Hi Dennis,

Here are my concerns about your answers

eut-1updated

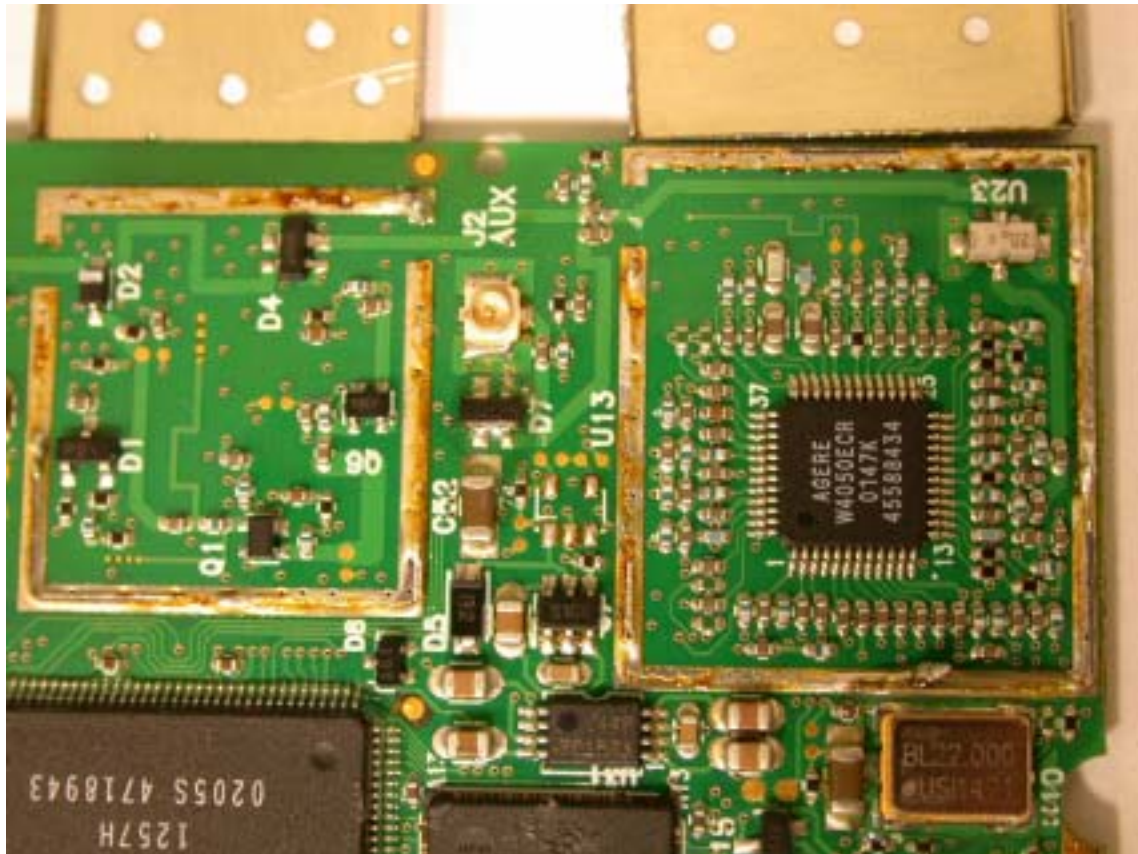
1 Your answer to item one is incomplete because it does not provide a separate photo of the circuitry under the metal shielding. This is required by the FCC. See 4 below

4 The photos of the circuitry under the shielding must be provided as a separate photo, not as part of the response document. The photos in the response document are blurred and are not adequate. Please provide separate photos that are clear.

ANS 1: I re-uploaded the EUT photos into internal folders.

see exhibit type “internal photo” EUT-1a; EUT-1b; EUT-1c; EUT-1updated

ANS 4: I re-uploaded the EUT photos into internal folders.

see exhibit type “internal photo” EUT-1a; EUT-1b; EUT-1c; EUT-1updated
(Same as item 1)
